SERVICE BULLETIN

Original Issue Date: **1/03**
 Model: **MPAC 1000™ Automatic Transfer Switches**
 Market: **ATS**
 Subject: **Control Board Failure in Some 480-Volt Applications**

Figure 1 Caution Tag

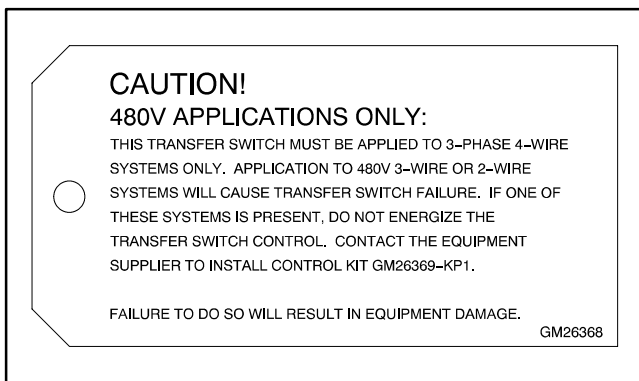
Transfer switches shipped from the manufacturer after September 15, 2002, have a red caution tag attached to the lead connector of the switch. The tag is shown in Figure 1.
